Appl. No. 10/734,834
Amdt. Dated September 27, 2005
Reply to Office Action of April 4, 2005

Attorney Docket No. 81876.0059
Customer No.: 26021

Amendments to the Drawings:

FIG. 1

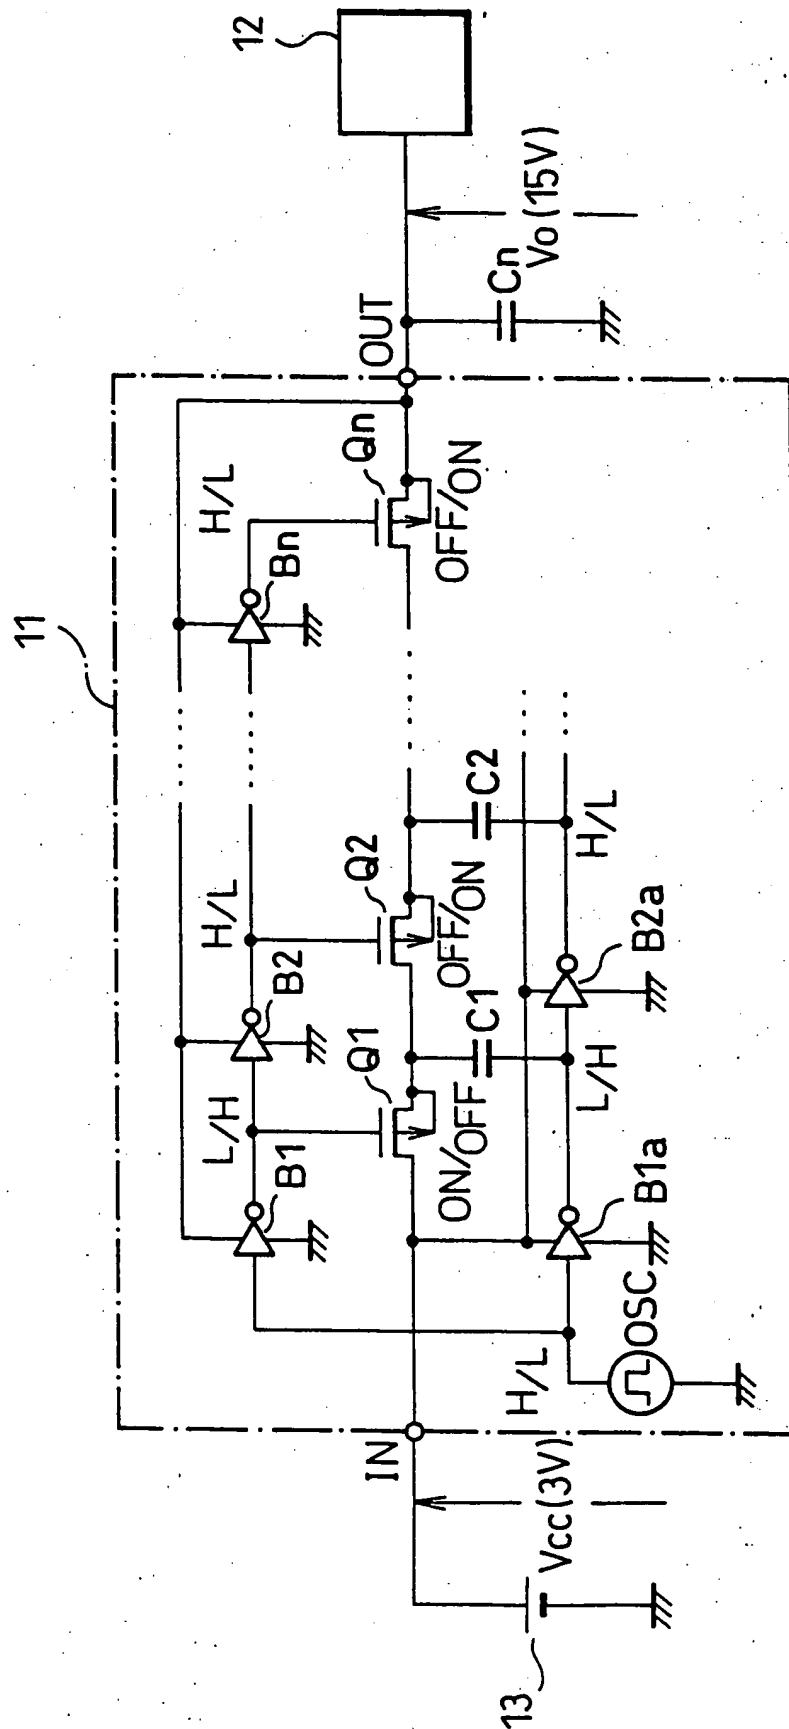
The attached sheets of drawings include changes to Figs. 1-4. These sheets, which include Figs. 1-4, replaces the original sheets including Figs. 1-4. In Figures 1-4, previously omitted element "Prior Art" has been ADDED.

Per Art
